HISTORIC LANDMARK COMMISSION
STAFF REPORT

Planning and Zoning
Division
Department of
Community & Economic
Development

Campbell Home
Legalization 470-08-13
840 East Sixth Avenue in the Avenues Historic District
June 4, 2008

Photos of building

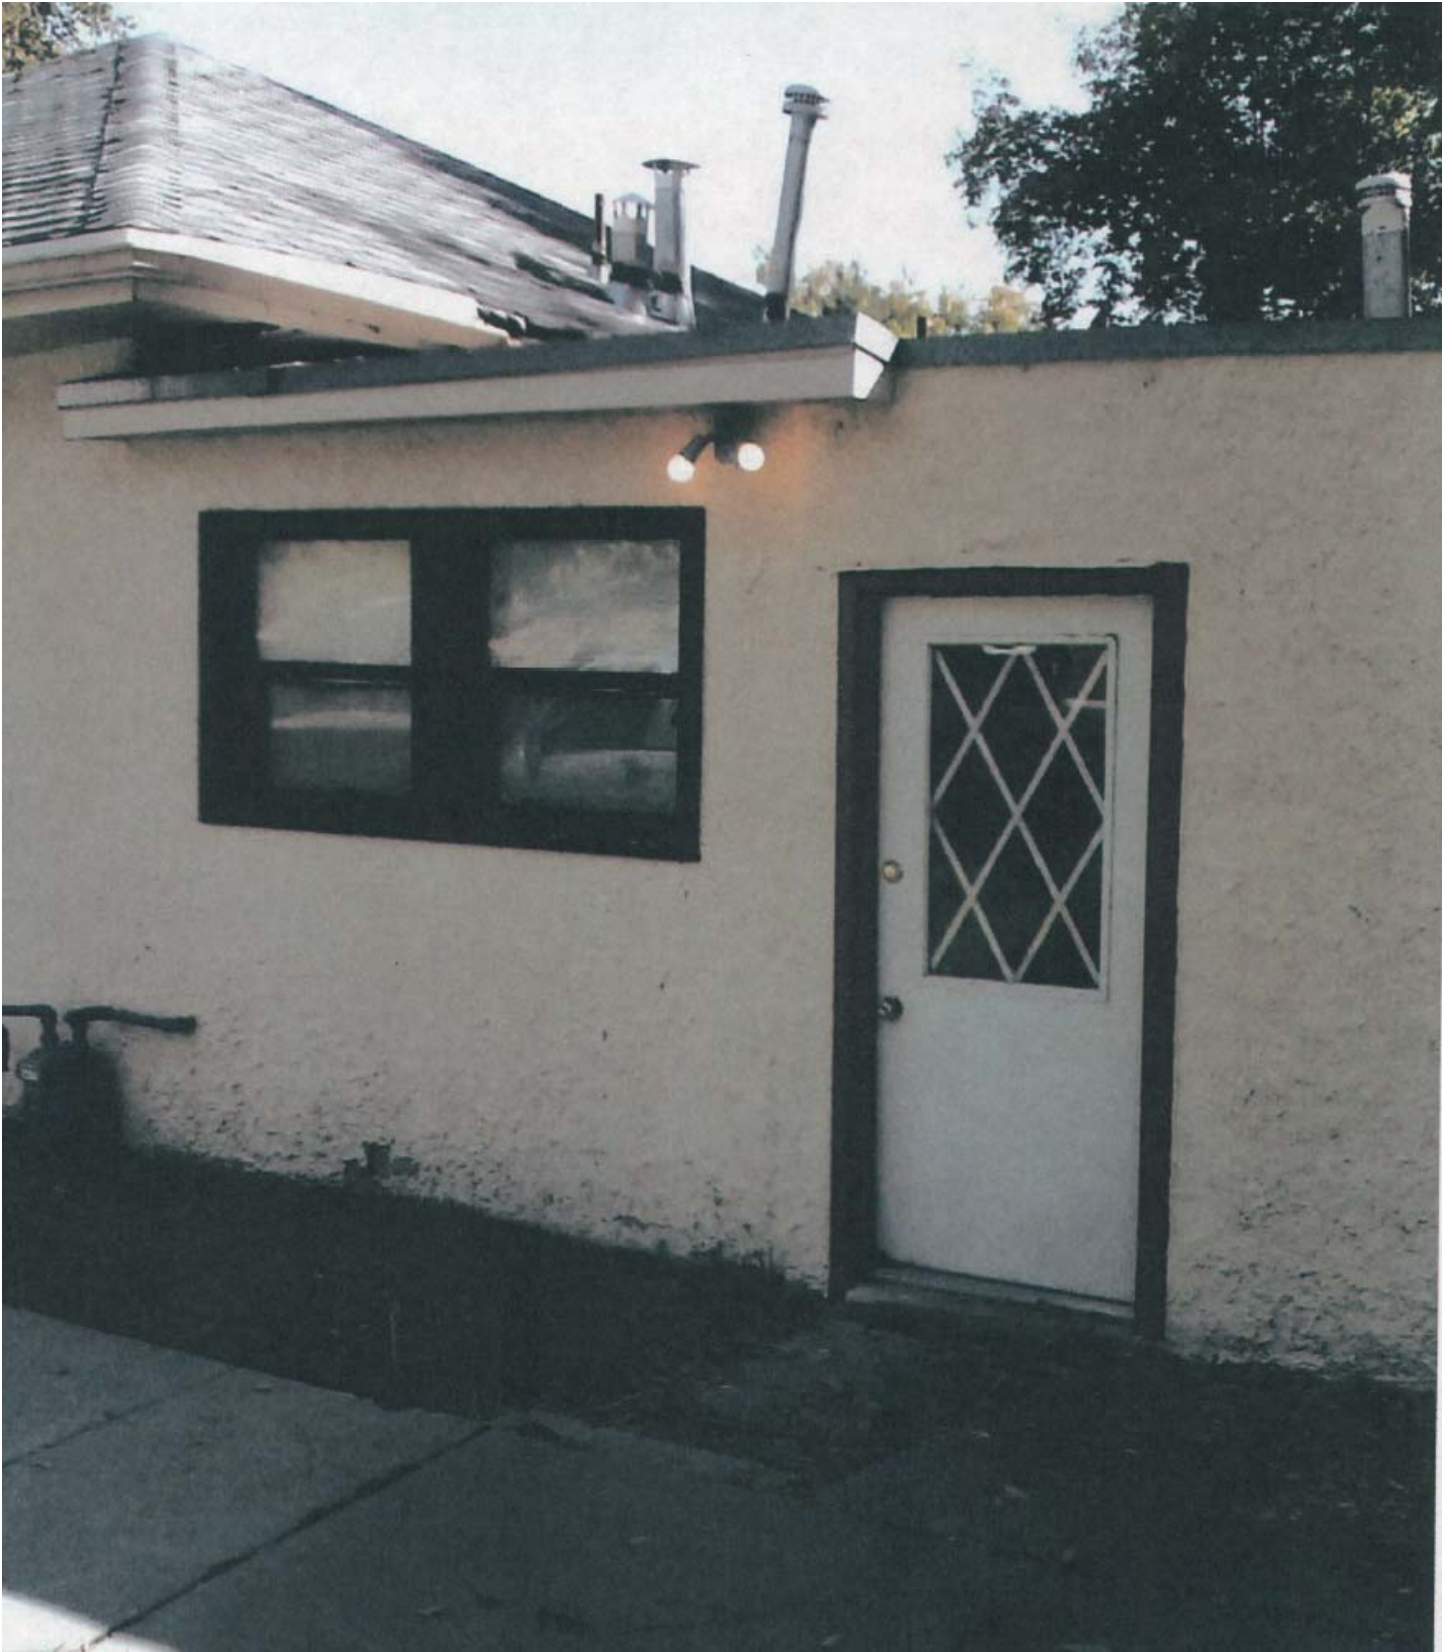
1. Replacement of a flat roof over an addition with a pitched roof.
2. Replacement of non-historic metal clad double-hung windows with vinyl windows with an internal muntin system.
3. Re-sizing of exterior windows.

4. That the Historic Landmark Commission denies the request to legalize the change in size and style of the windows in the middle opening on the north façade, as this is an inappropriate measure that will alter the historic character of the building as seen from the public way. The middle opening shall be restored to its original size and proportion.

Discussion: The applicant has replaced the metal clad windows on the building (the original wood windows were replaced long ago) with vinyl windows. On the north elevation there are three sets of windows; to accommodate the kitchen remodel, the middle opening was resized and replaced with a smaller horizontal slider type window. By doing this, the historic look of the north façade has been altered from its original orientation to a more contemporary look, as slider type windows were not as common historically as larger double-hung windows. The Historic Landmark Commission has allowed the use of horizontal sliders on secondary locations when necessary for egress purposes or where they replaced original casement, awning or hopper windows, so the exterior appearance is similar to the original window. As a corner property, staff recommends that the middle opening be restored to its original size and proportion.

Finding: Staff finds that the change in size and style of the windows in the middle opening on the north facade is an inappropriate measure that will alter the historic nature of the building and is inconsistent with this standard.

Discussion: The design of the roof structure was constructed as an extension of the existing ridge line of the main home, and is built in the same style with the same roofing materials. Nevertheless, the structure is distinguishable from the rest of the roof structure through an obvious seam that delineates the old roof line from the new.

Based upon the analysis and findings included in this staff report, Planning Staff recommends the Historic Landmark Commission legalize the changes to the contributing home located 840 East Sixth Avenue, subject to the following conditions:

1. That the Commission legalizes the pitched roof of the rear addition, as this portion of the home is a later addition and there are no outstanding architectural, physical or historic features associated with the addition

2. That the Commission approves the use of vinyl replacement windows that match the existing window configuration. They are located on secondary and tertiary elevations where no decorative or character-defining architectural features will be removed as the original windows were replaced.

3. That the Historic Landmark Commission denies the request to legalize windows with an internal muntin system, as this design is not consistent with the historic character of the building or the historic district.
